<b>COA #</b> <b>2014-COA-109(CAMA)</b> <b>Part B</b> <b>2014-VHP-016</b>	<b>INDIANAPOLIS</b> <b>HISTORIC PRESERVATION COMMISSION</b> <b>STAFF REPORT</b>	<b>Hearing Date</b> <b>SEPT. 3, 2014</b>
<b>602 and 625 E. 11<sup>th</sup> Street</b> <b>CHATHAM-ARCH/ MASSACHUSETTS AVE</b>		<b>Continued from</b> May 7, 2014 (Preliminary Review) June 4, 2014 July 2, 2014 August 6, 2014 August 12, 2014
<b>Applicant &amp; mailing address:</b>	Milhaus Development, LLC 530 E. Ohio, Suite A Indianapolis, IN 46204	
<b>Owner:</b>	same	
<b>COMBINED CASES</b>		
<b>IHPC COA:</b>	<b>2014-COA-109 Part B (CAMA)</b>	Certificate of Appropriateness for: <ul style="list-style-type: none"> <li>• Demolition of three non-contributing buildings</li> <li>• Construction of 84 condominiums</li> <li>• Variances of Development Standards</li> </ul>
<b>Variances:</b>	<b>2014-VHP-016</b>	<ul style="list-style-type: none"> <li>• Variances of Development Standards of the D-10 zoning ordinance for:             <ol style="list-style-type: none"> <li>1. Less front yard setback than required at Broadway St, 11<sup>th</sup> Street, Park Ave and 10<sup>th</sup> Street</li> <li>2. Construction within the required clear sight triangl

## REVISED PLANS

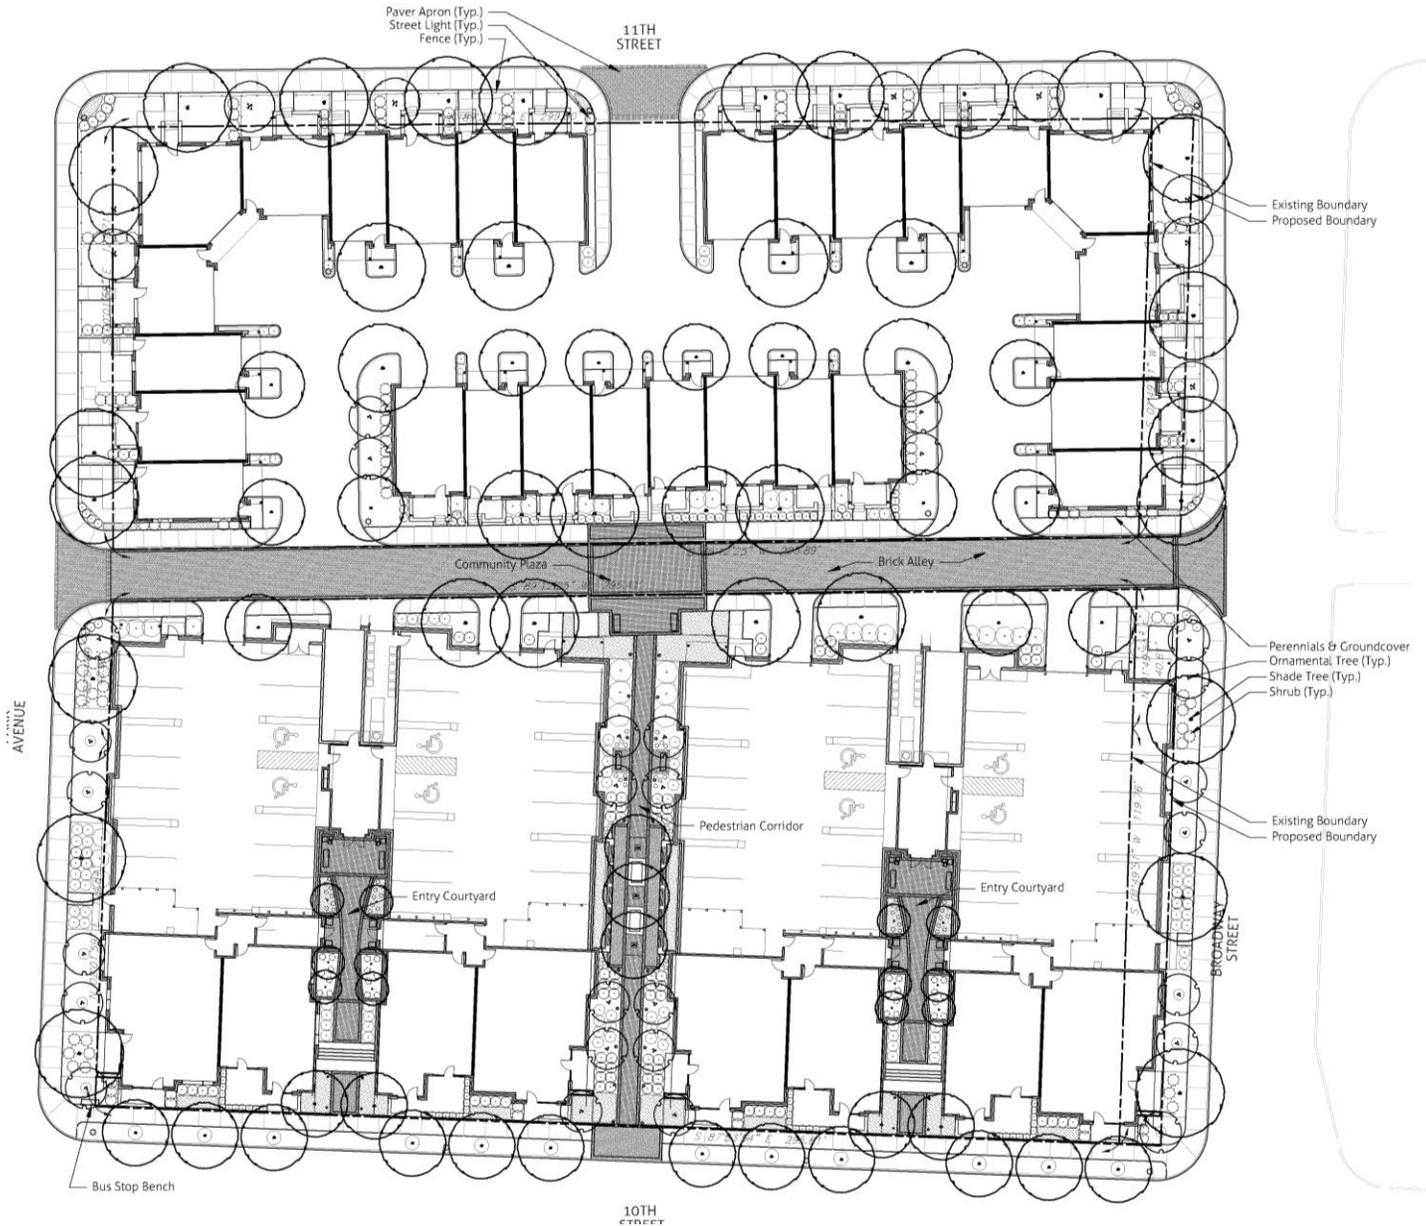
This month, the applicant is proposing revised plans that show the following changes addressing the Commission's concerns and comments:

- The east-west alley and the north entrance apron are "bricked" with pervious concrete pavers.
- A tree lawn is added along 10th Street.

- 1st Floor patios expanded and delineated with low brick walls/black metal railings and plantings.
- 10th Street unit entrance canopies are expanded.
- Brick height raised to 2nd floor.
- Brick veneer replaces lap siding at the 1st floor recessed patio.
- A second brick rowlock course detail added to 1st floor.
- Sconce lighting and unit addresses are shown on 3D drawings.

- Lap siding replaces brick veneer at 2nd and 3rd floors of recessed face next to the corner tower.
- A second brick color is identified. The darker brick is on outside building wings and the lighter brick on inside wings.
- Lap siding on each of the four wings is to be a different color.
- A cooler gray tone is selected to replace the warm tan cast stone.
- The dark gray color of the hardie panels is to be replaced with a lighter gray color.

- The units featuring a vertical bump-out and a balcony along street will get an expanded raised entry patio and brick.
- Veneer will be added to the first floor of the bump outs.
- The units with a balcony along garage alley are to get a grade-level patio.
- The units in the central cluster with a balcony along the "alley" are to get raised patios.
- Shed roofs will be added above all balconies.
- Sconce lighting and mailboxes are shown in the drawings.

- Color scheme has been made more uniform.
- A cooler gray tone is selected to replace the warm tan cast stone.
- Corner tower bump-outs extend to the ground and are all brick with a simplified gable roof.
- Porches are made more prominent, especially on corner units.
- The overall look appearance is simplified.
- Additional color is used.
- Entry canopies are supported by brackets instead of cables for a more residential feel.
- The east four units of the center cluster are moved north 24 inches to delineate the two center units.

- Lap siding panels between windows on brick facades have been removed.

Staff believes that the proposed changes address the Commission’s concerns well and in turn, improve the overall design of the project. Staff believes that the proposed changes are appropriate and recommends that they be approved with the updated plans.
